Groundwater Application Review Summary Form

Application # G- 19013

PUBLIC INTEREST REVIEW FOR GROUNDWATER APPLICATIONS

TO: Water Rights Section Date 12/07/2021
 FROM: Groundwater Section Jen Woody
 Reviewer's Name
 SUBJECT: Application G- 19013 Supersedes review of 10/04/2021, 9/17/2020, 10/29/2020
 Date of Review(s)

Figure 2. Well Location Map. Proposed POA is 30 feet NE of WASH 3526

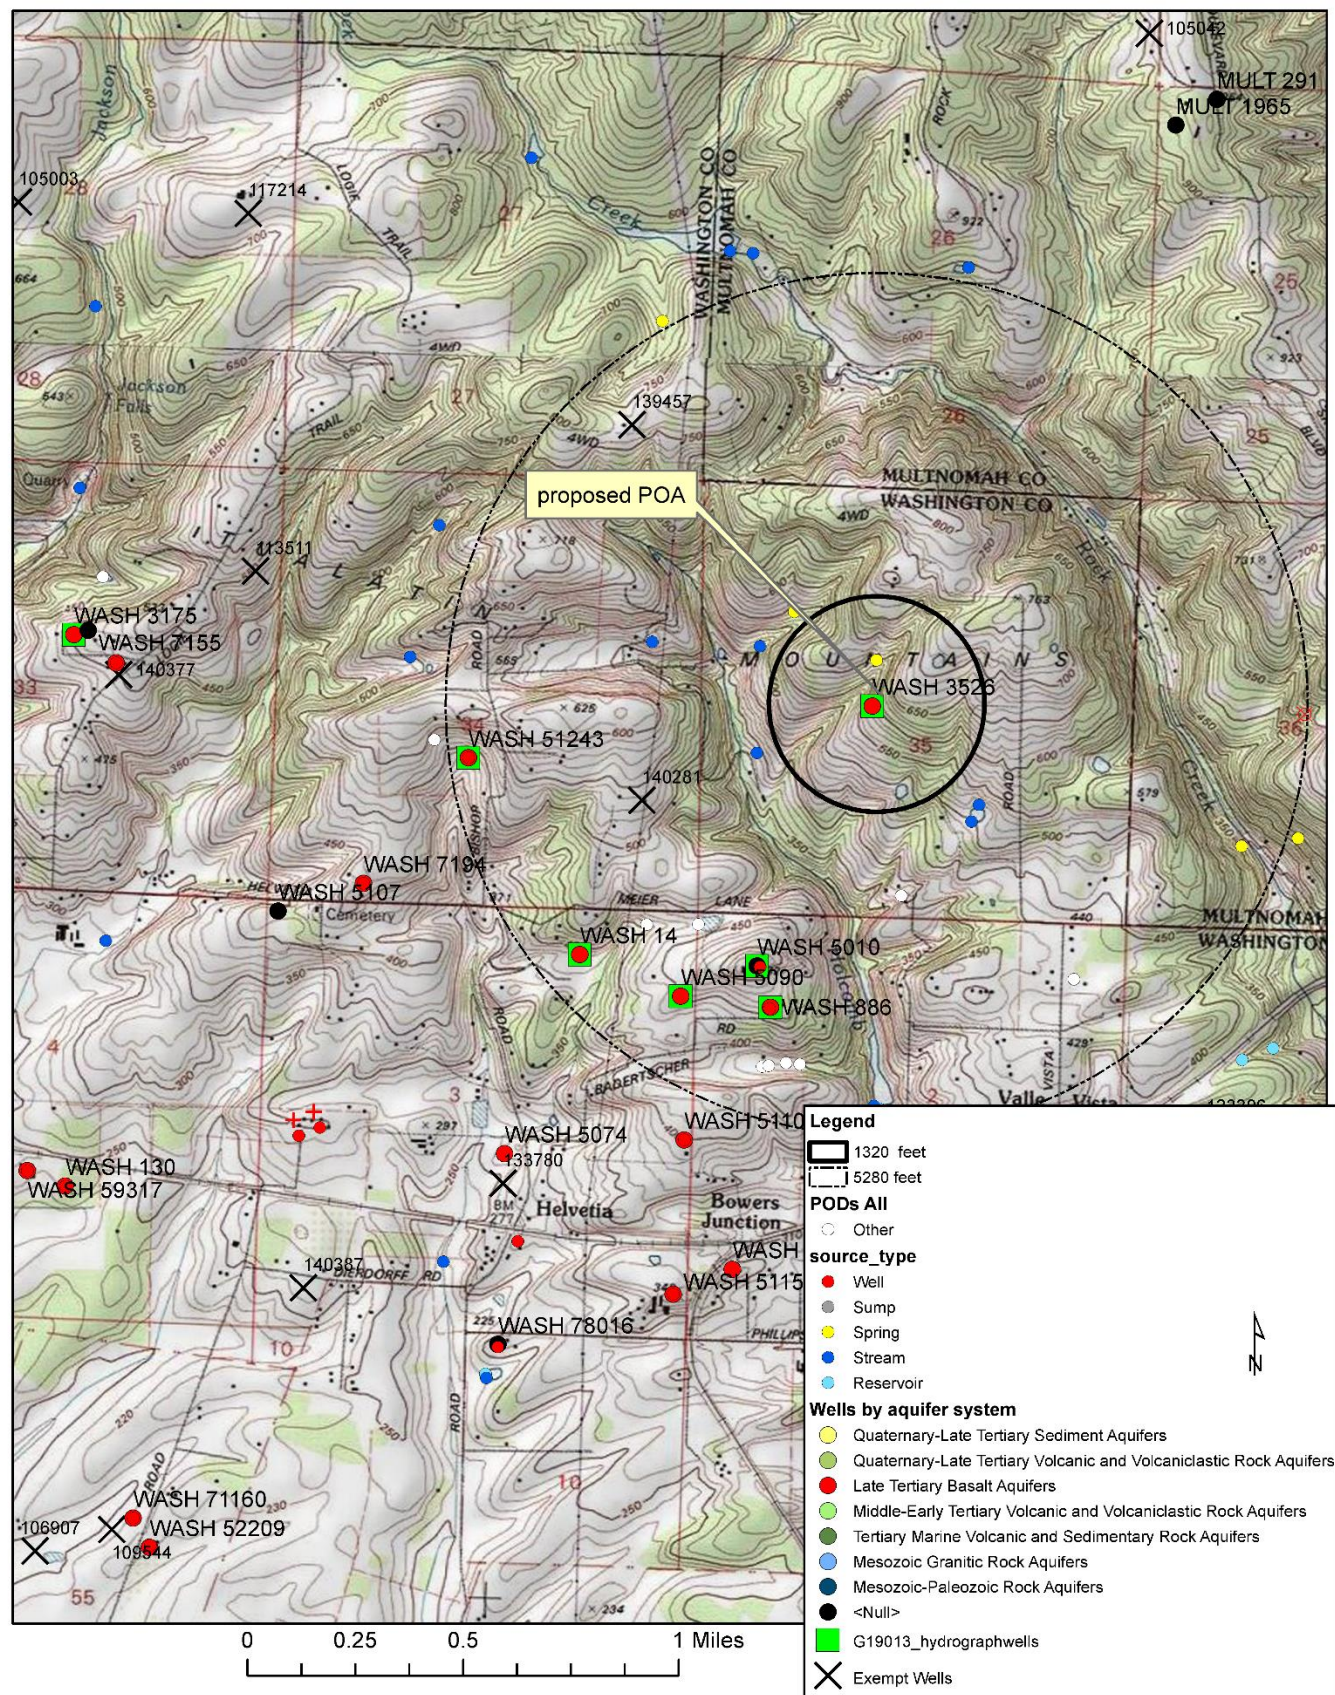
A4. **Comments:** This re-review assesses a new proposed well location and new well construction.

Figure 3. Water-Level Measurements in Nearby Wells

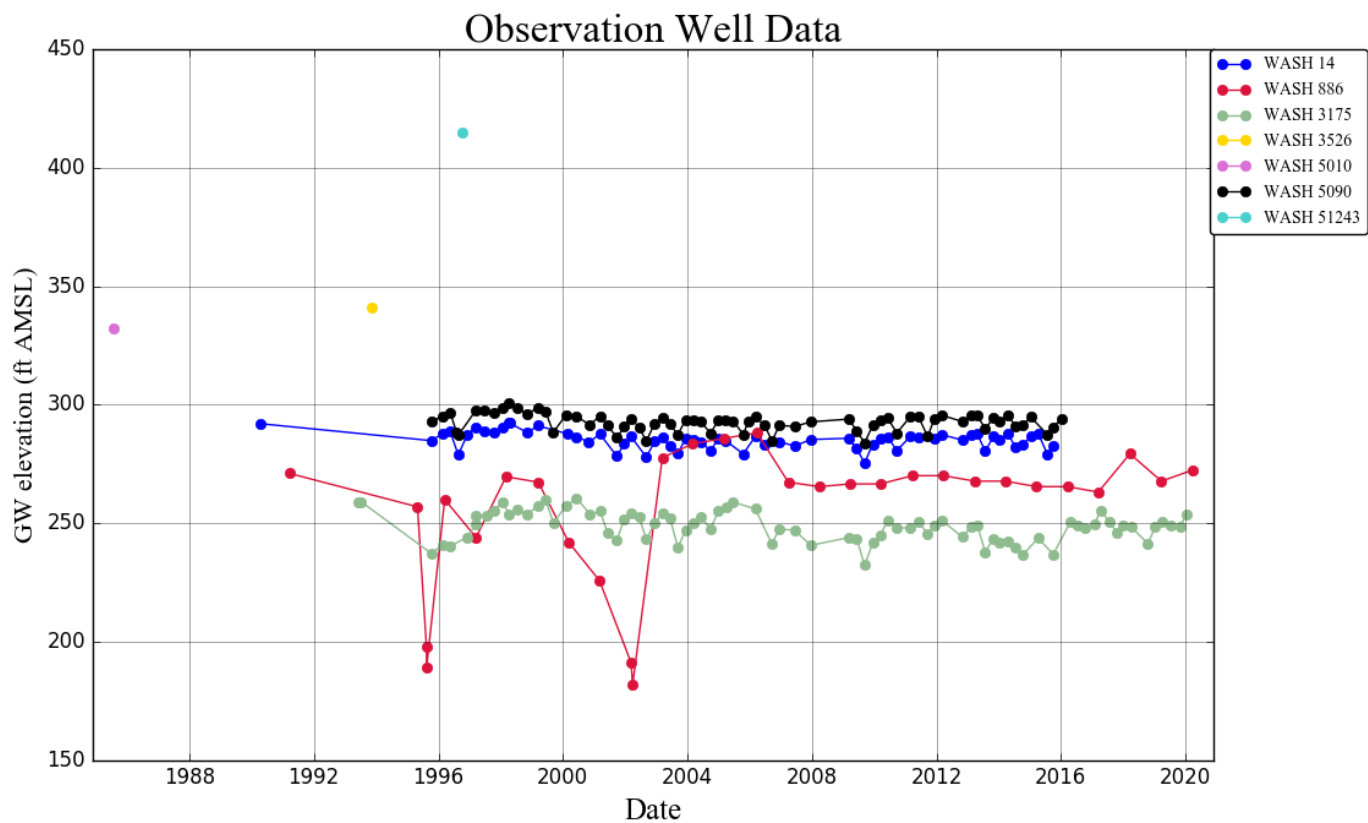
The proposed pumping rate of 9 gallons per minute (gpm) is unlikely to create drawdown interference with nearby wells that prevents access to water. Most neighboring tax lots are larger than 20 acres, indicating development by exempt wells is sparse. Nearby wells access a variety of water bearing zones within the CRBG aquifer system and show reasonably stable trends (see Figure 3). Water use and water level monitoring conditions are recommended to protect existing users. _____
